Service Bulletin 15

<h1>Service Bulletin</h1>		
1. General		
(a) Service Bulletin No.:	15	
(b) Revision / Date	Revision 0 - 04 Oct 2007	
(b) Title:	Triple and Quadruple Burner Frames -Weld Inspection

(c) Description:	Detailed visual inspection of weld at gimbal bearing (triple burner frame cross bar) and attachment of cross bar to outer frame (triple and quadruple burner frames).

Figure 1

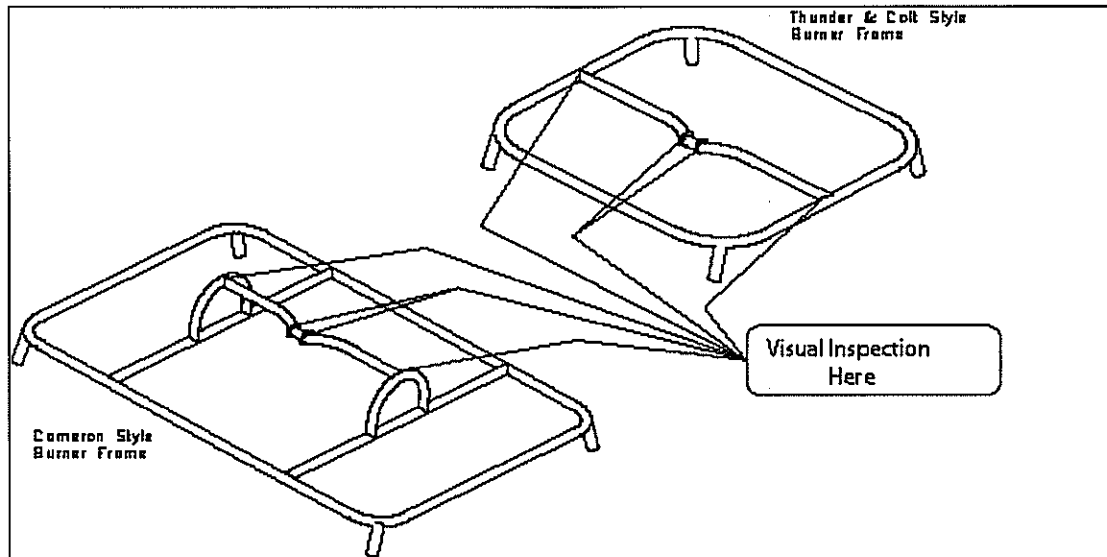
1. Visual inspection through 360° at weld around gimbal bearing (triple burners only) and at attachment of cross bar to bridges on outer frame (triple and quadruple burners). This may be carried out by the pilot. Refer to Figure 1.
2. Remove from service any frame showing signs of cracking.
3. Report any rejections to Cameron Balloons Ltd. (CBL).
4. Cracked burner frames can be returned to service by incorporation of modification C484.
5. Inappropriate ground handling of basket to be discontinued.
